SUBJECT: **Scott's Seafood Restaurant, Jack London Square, Oakland, Alameda County**
(For Board consideration on April 6, 2015, Second Pre-Application Review)

**Scott's Restaurant
Jack London Square
Public Pavilion Modifications and
Public Access Enhancements**

SUBJECT: Approved Minutes of April 6 2015 BCDC Design Review Board Meeting

A.3.2

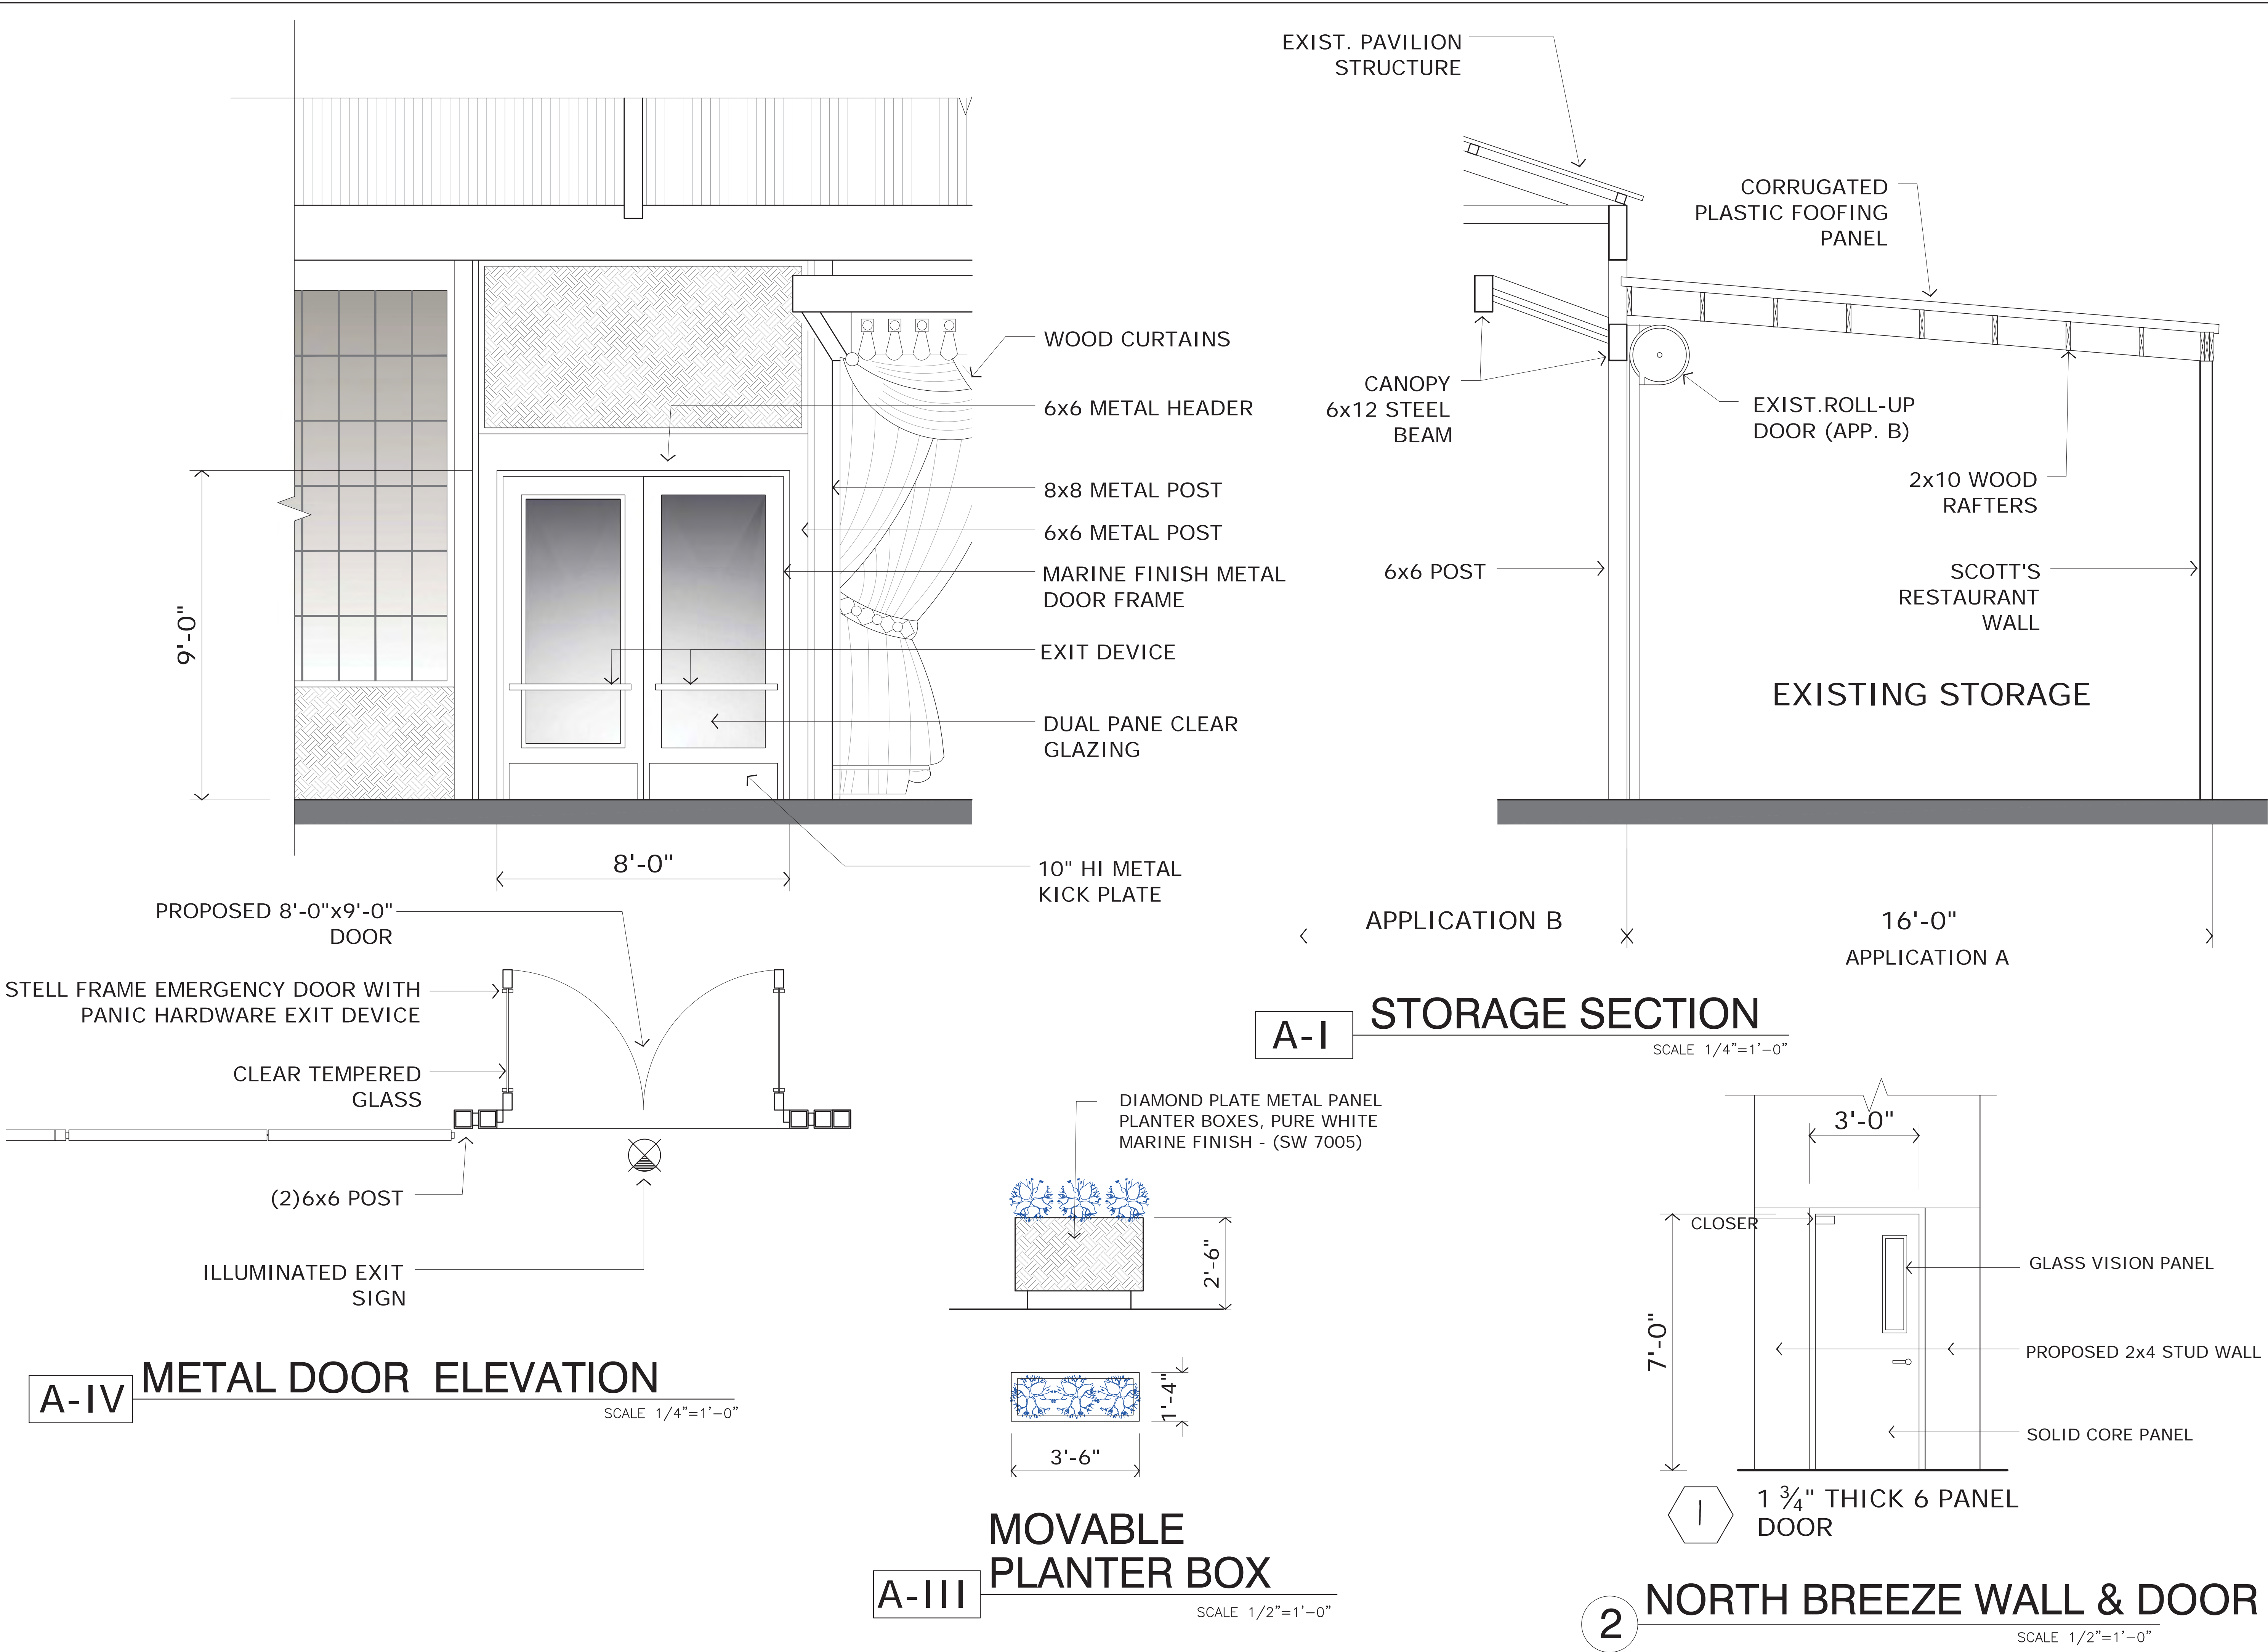
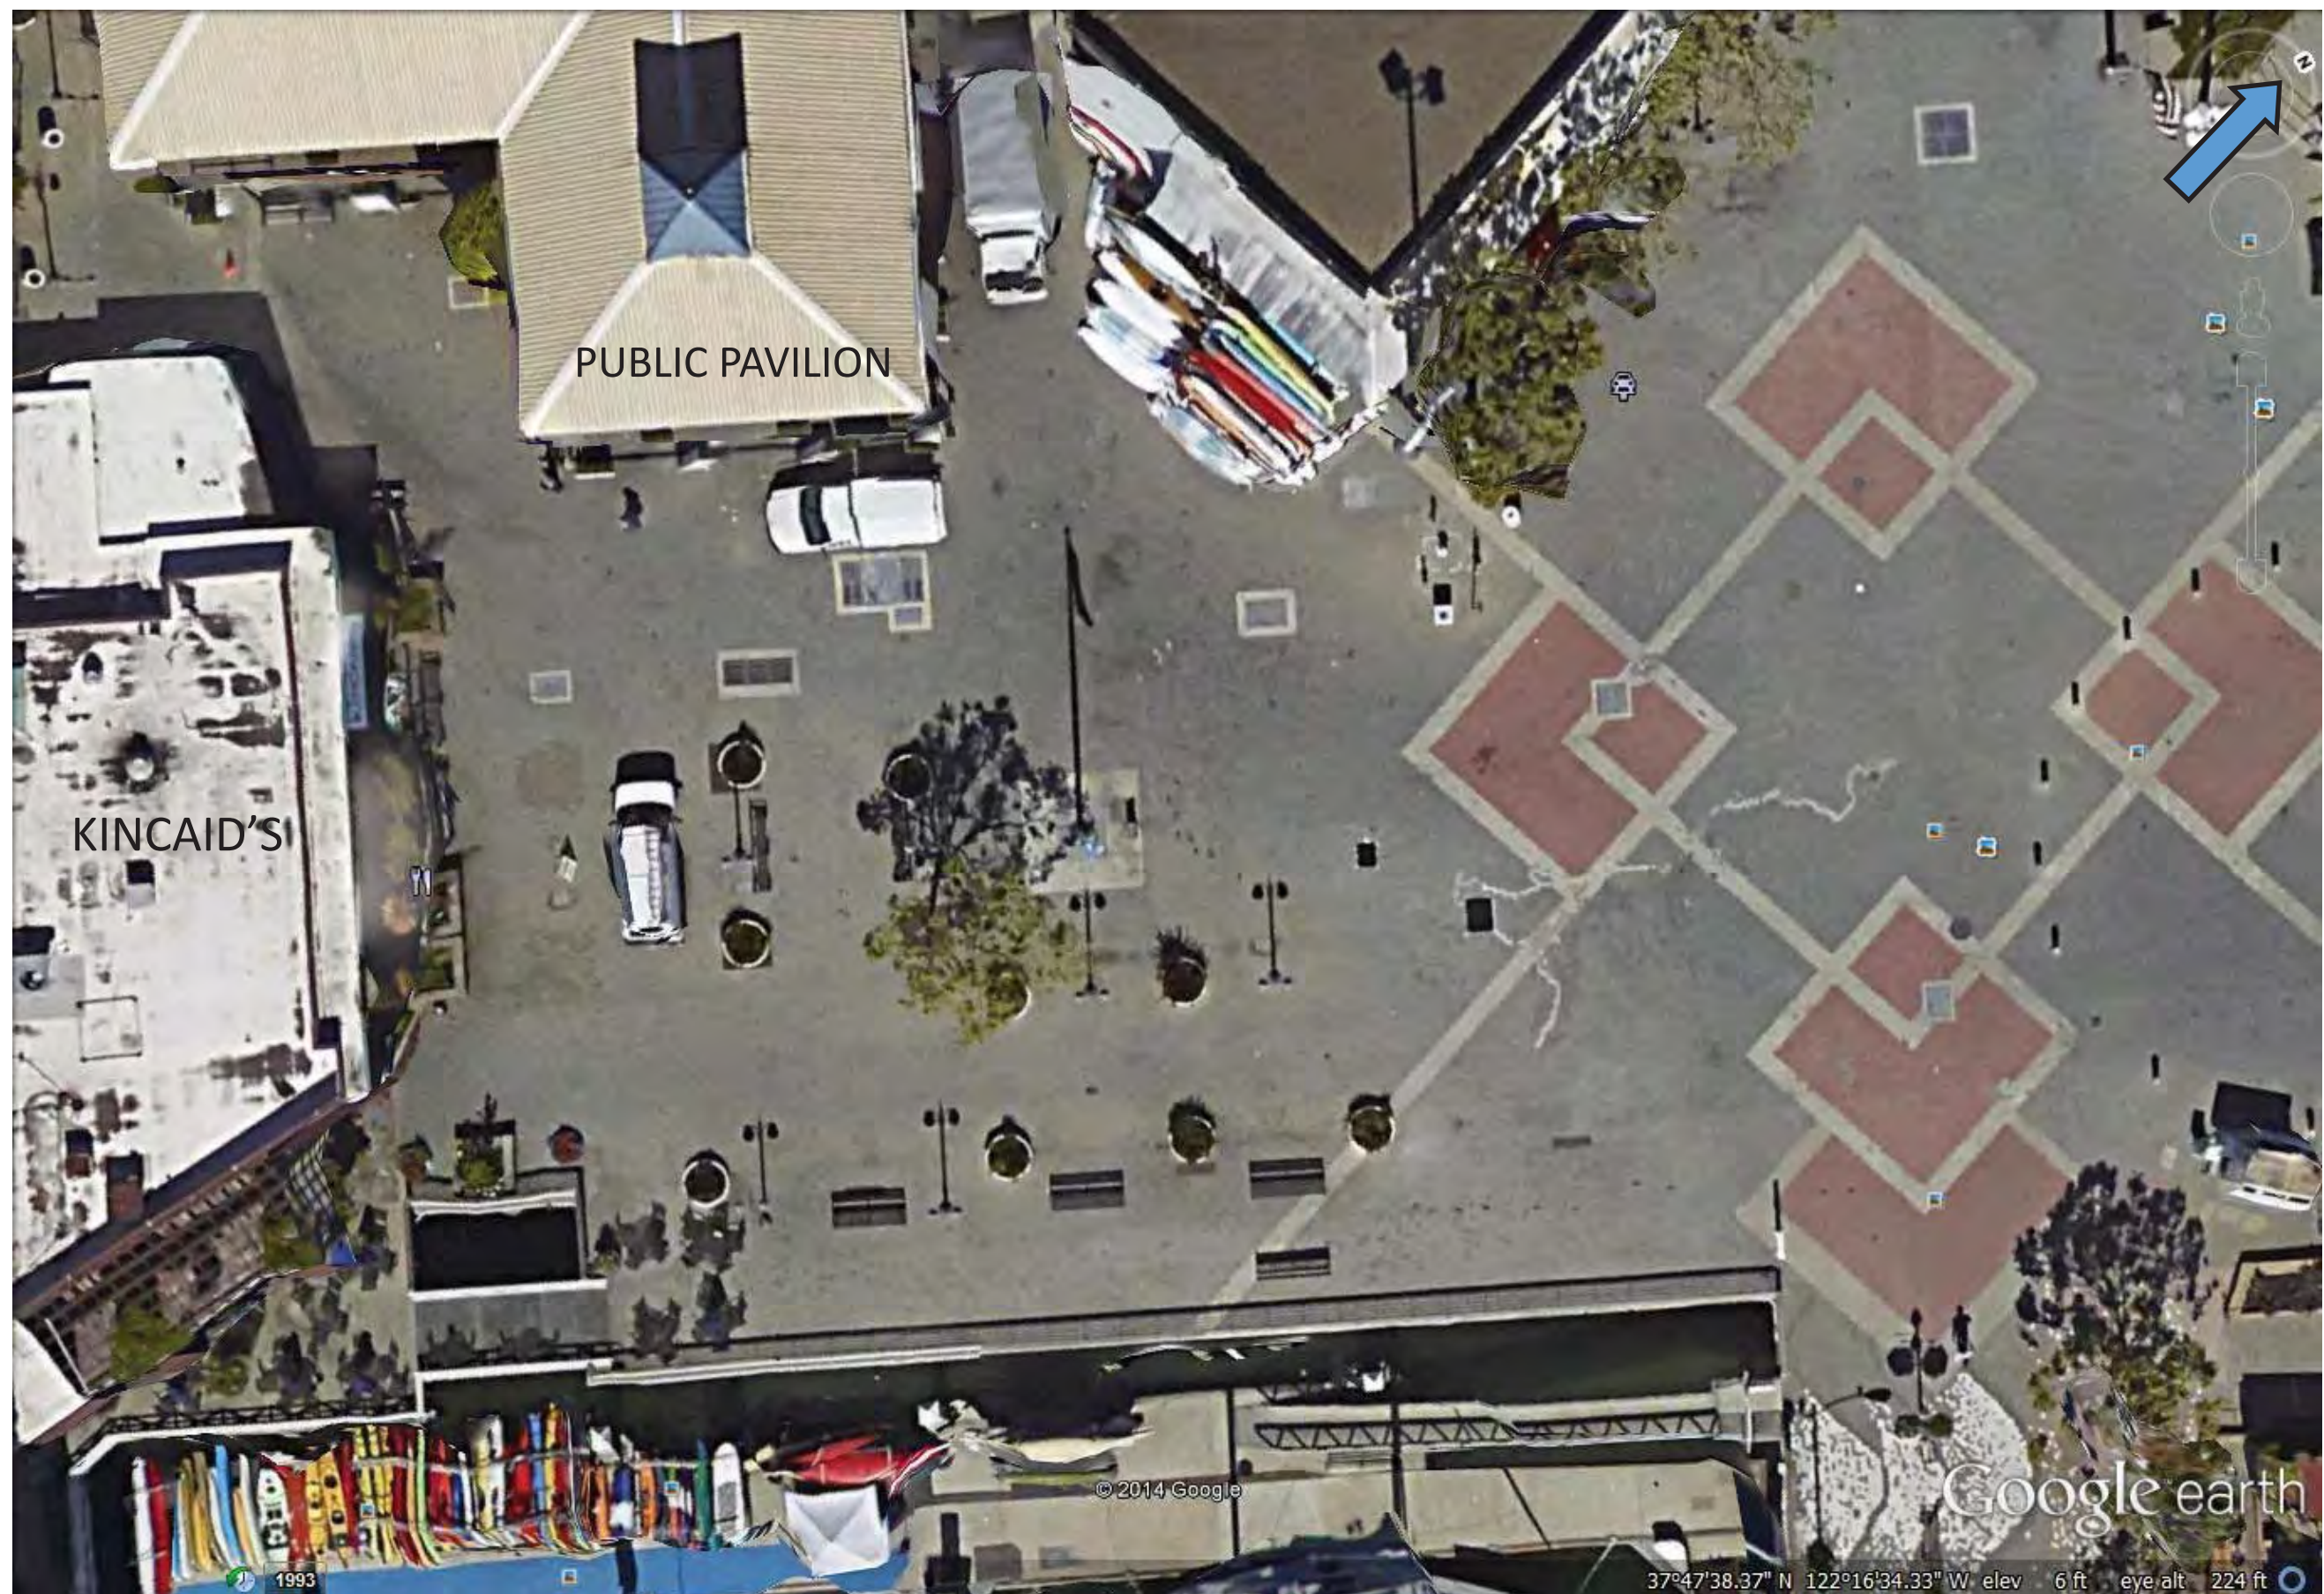
8. The Board questioned the practicality of moving the steel planters in and out of place and recommended against using them. Some Board members stated that the planters would create an unwanted barrier in this area. One Board member questioned whether it is appropriate to include planters within the context of this wharf setting.

Mr. Thompson stated that all new elements, such as paving, seating, a display boat or other exhibits, should work to draw the eye towards the water. He further noted that the proposed planters would block movement towards the water, do not provide any enhancement, and do not appear to be needed.

Applicants' Response: *The applicants continue to propose the placement of the steel planters around the pavilion perimeter in order to protect the wall panel system from being hit by trucks. The proposal includes moving the planters each time the pavilion converts from private use to public access, and storing some of the planters in the delivery area shared with California Canoe & Kayak and storing the remainder of the planters in the Port's public access area between the east wall of the restaurant and the pavilion.*
